Wiltshire Council Planning Consultation Response

Jocelyn Sage
Senior Conservation Officer
Wiltshire Council Conservation
(South/West)

Application No: **PL/2025/08144 PP and /08364**

Alterations to interior of existing building, adaptation & extension of existing side extension, relaying of forecourt, general repairs & upgrades to fabric, provision of PV array to rear roof slopes & change of use to suit new leisure facility & cafe.
Dewey House, North Row, Warminster, BA12 9AD

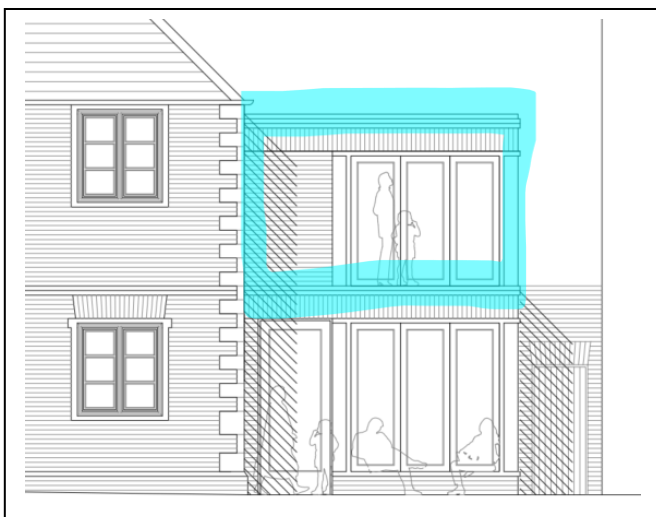
It looks like some of the existing structure, to the rear, is retained and incorporated into the new/extended side extension. The new extension projects forward (although marginally set back from the principal elevation), covering the existing side elevation. It appears that the existing ground floor mullion window is retained.

A flat roof is proposed (mounted with flush? Roof lanterns). In terms of the handling of the front elevation, the drawing (insufficiently scaled for a listed building application) is largely glazed.

This element is set back. The drawings are somewhat misleading as presumably there would need to be a balustrade of some sort around the edge of the proposed terrace?

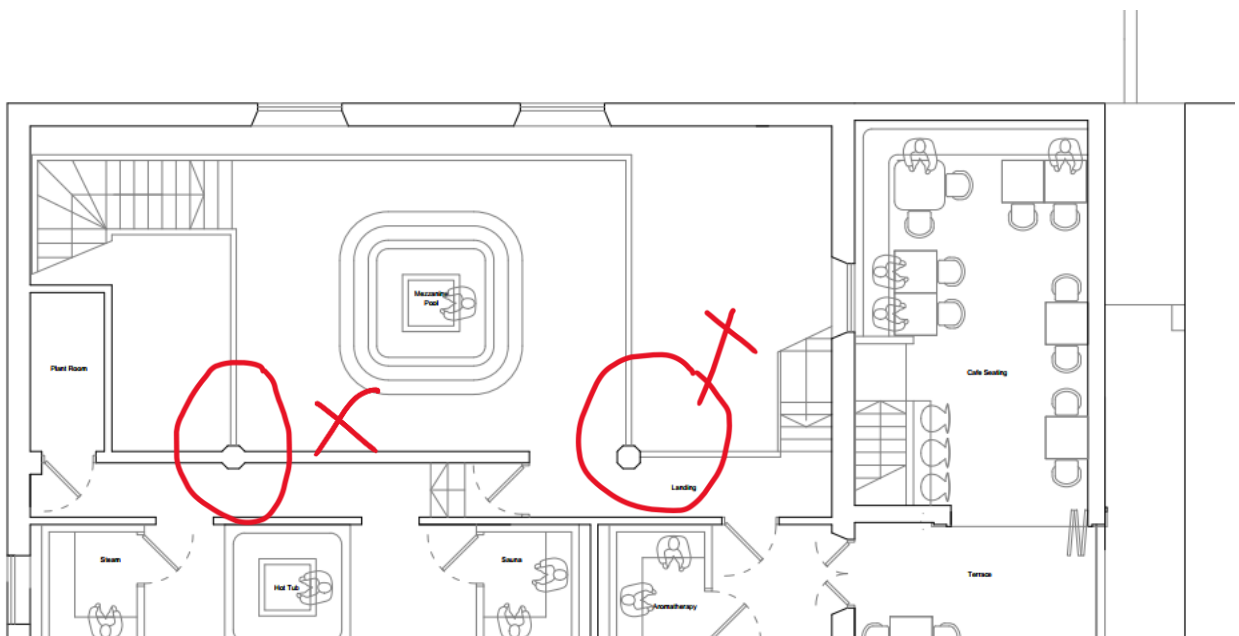
What is the impact on the side elevation (historic fabric)?

The current (altered) first floor door would remain to access the 'terrace'. The first floor window (rear side) would be concealed by the two-storey element – but it appears in the floorplans so retained and internalised presumably. Brickwork, stringcourse and stone quoins covered up by extension. At ground floor – blocking of rear side doorway and internalising a window.

A two-storey linked extension is problematic because of the scale and impact but perhaps not impossible. I would strongly recommend that the extension is linked to the existing dwelling in a largely glazed way so that there is a clear visual separation between the host building and the extension. The new extension needs to be a 'wow' moment. I suggest also that the extension is set slightly further back than is shown.

In terms of the current proposals, I would avoid brick – given the existing building is brick. Much more information on the handling of abutment of the new and old is required, (ie there is a large downpipe in the middle of the wall – would this remain?) including section details. The existing side wall should remain unplastered (also there are remnants of render – what would happen here? Consolidation/repair or removal and if so, how?).

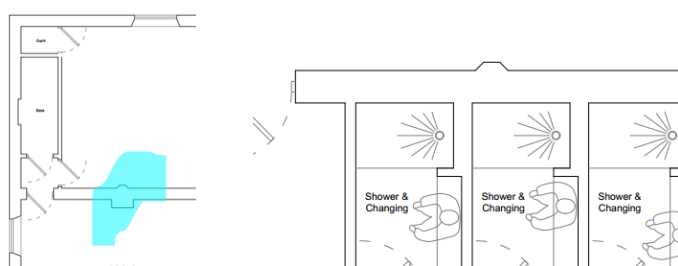
At ground floor in the earlier part of the building – three separate WCs are installed (where are the services coming from?), the second meeting room is divided up into 3 changing rooms and a treatment room.

What is that bit of masonry on the north wall which is proposed for removal? Presumably, if tall ceilings, the units like the changing rooms don't need to be full height (following the site visit, I understand that details such as this have yet to be worked out). One positive is removal of a partition that cuts across a window.

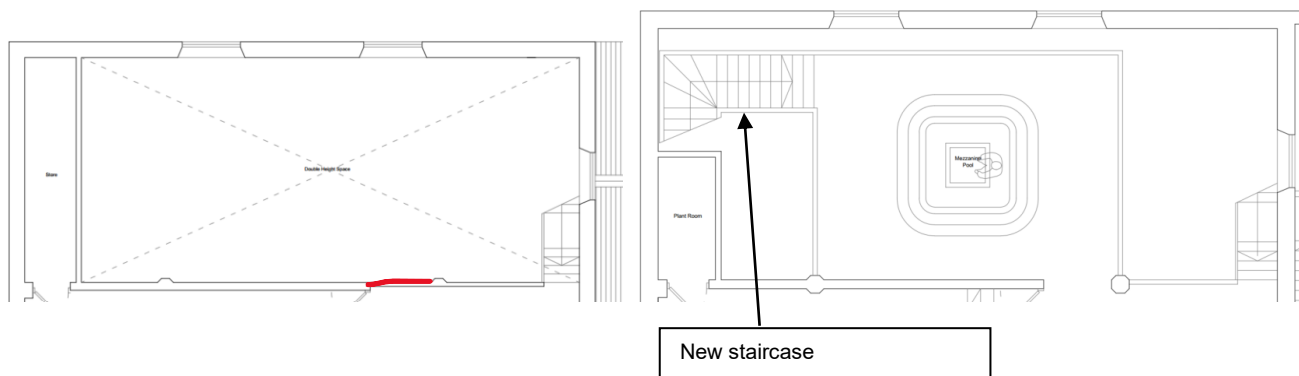
Forgot to check this at the site visit

Proposed first floor – new staircase – no objection subject to acceptable details (see previous comments).

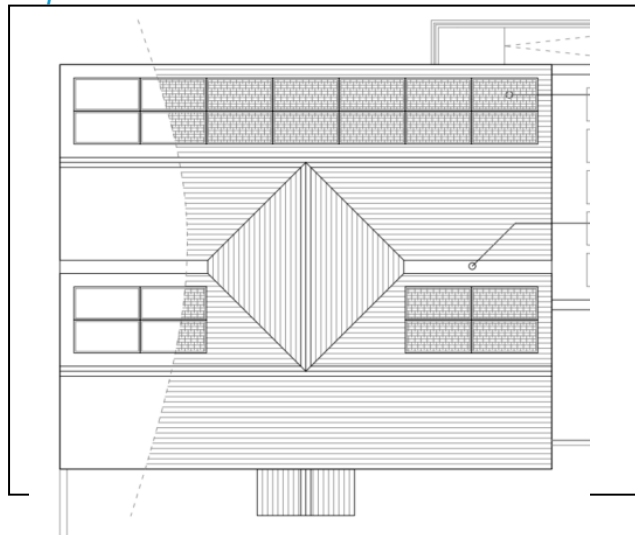
At the front of the building (the older core), there are two rooms – a corridor is formed: a cold plunge pool, a series of showers, steam rooms, saunas etc.
